**CERTIFICATE OF APPROPRIATENESS**

**Property:** 501 Euclid Street, lot 16, tract 15, block 22, Woodland Heights Subdivision. The property includes a historic 1,194 square foot residence and a 1,187 square foot accessory structure situated on a 6,200 square foot (62' x 100') corner lot.

**Proposal:** Alteration – Addition: Construct a 1,432 square foot two story addition to the rear of a south facing 1,194 square foot Contributing residence and an east facing 1,187 square foot Noncontributing accessory structure.

**HAHC Action:** Approved

**SOUTH ELEVATION – FRONT FACING EUCLID STREET**

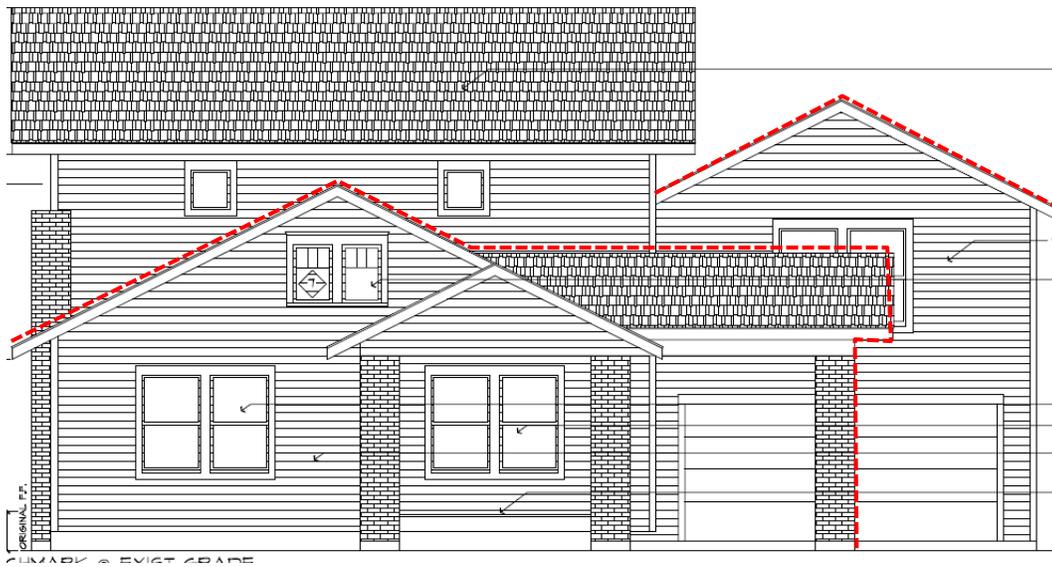
**Front Elevation:** Remove the non-original front porch enclosure restoring the original open front porch. Reinstall a pair of historic wood 3 over 1 windows in the location of the existing non-original attic vent. Install an overhead lifting garage door on the front elevation of the accessory structure.

The addition will be located at the rear of the original structure and feature a pair of south facing windows on the second floor.

**EAST SIDE ELEVATION**

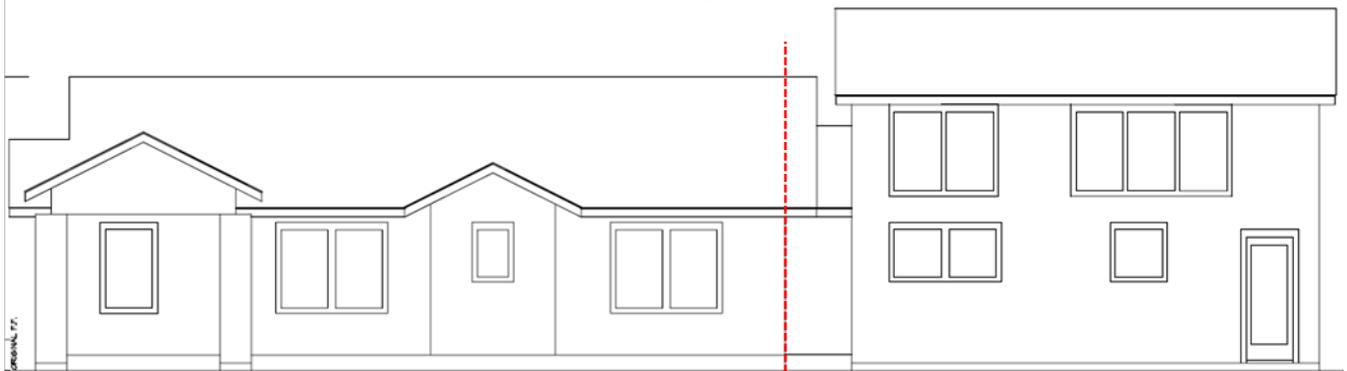
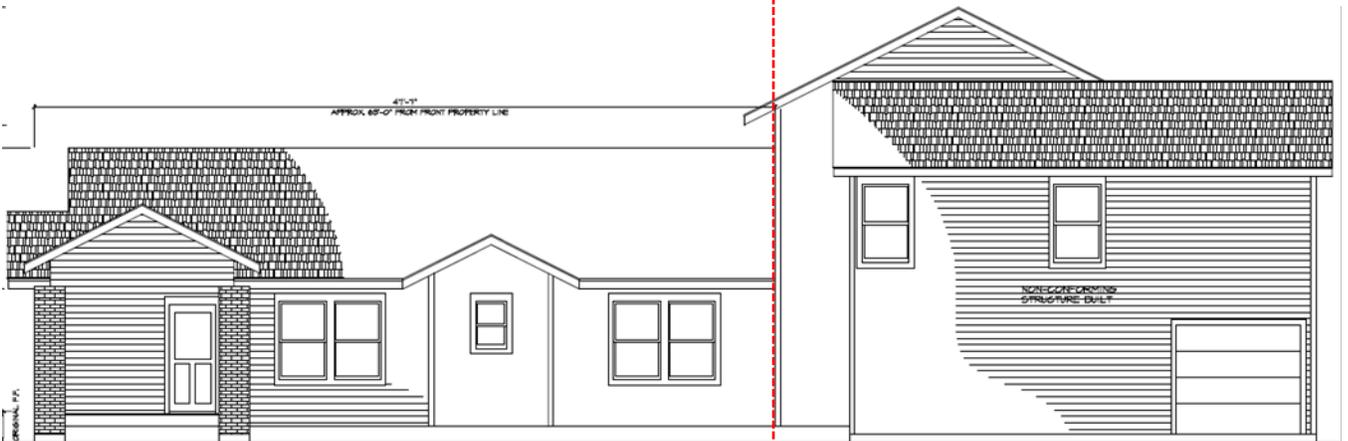
**Side Elevation:** Install a new side facing front door at the restored front porch. Addition will start at the rear wall of the original house.

The existing windows and entry door on the accessory structure will be replaced with a overhead lifting garage door on the first floor and a pair of windows on the second.

WEST SIDE ELEVATION

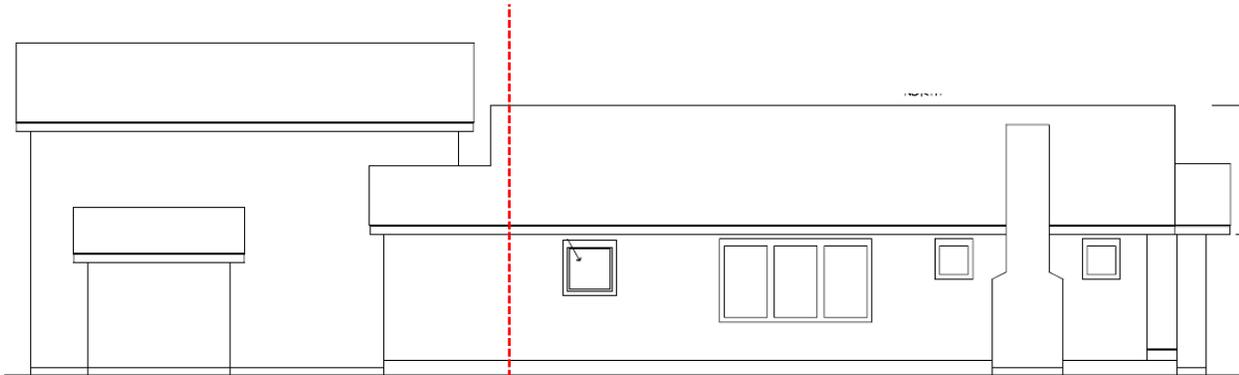
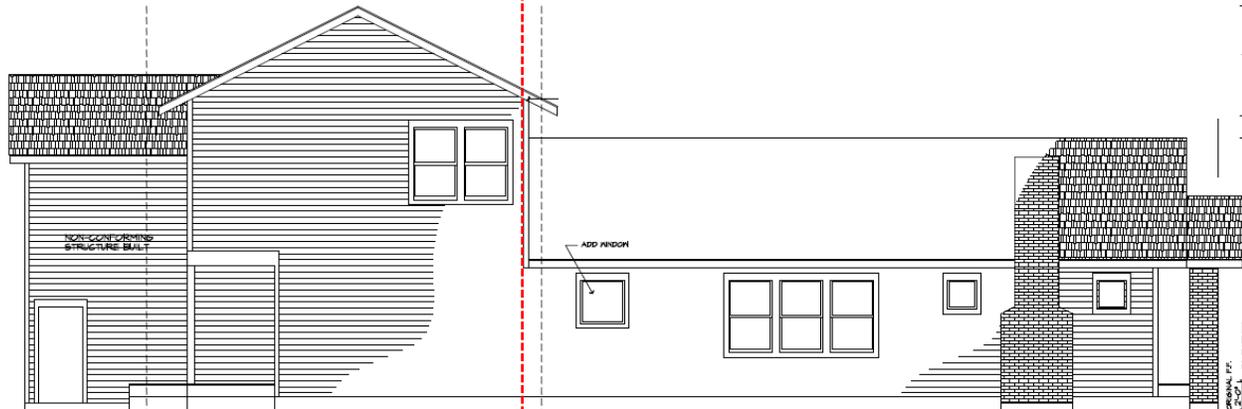
**Side Elevation:** The addition will begin at the rear of the original house. A non-original rear addition will be removed in order to construct the new addition. The addition will feature a pair of west facing windows.

SITE/ROOF PLAN

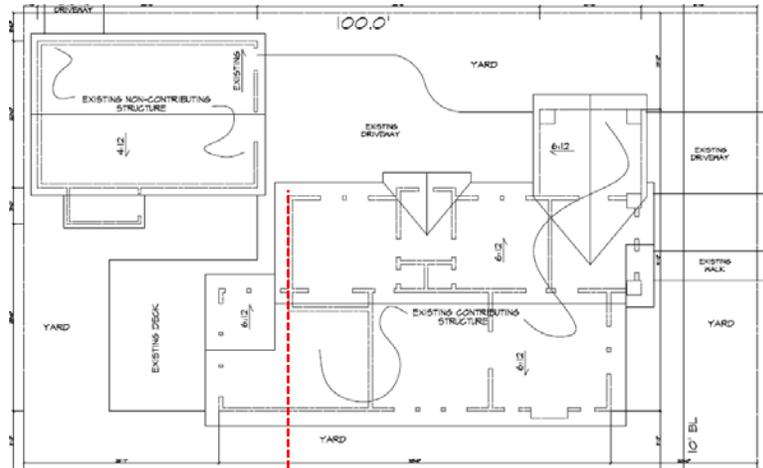
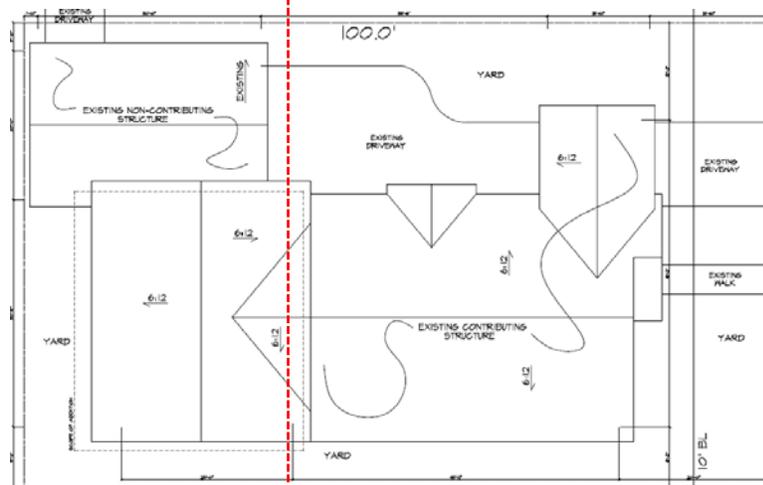
The applicant proposes to construct an addition at the rear of both structures that will connect the Contributing residence and Noncontributing accessory structure. The addition will necessitate the removal of the rear addition and begin at the rear wall of the existing residence. The addition will measure 28' deep by 30' 6" wide with an eave height of 20' 4" and a ridge height of 27' 10".
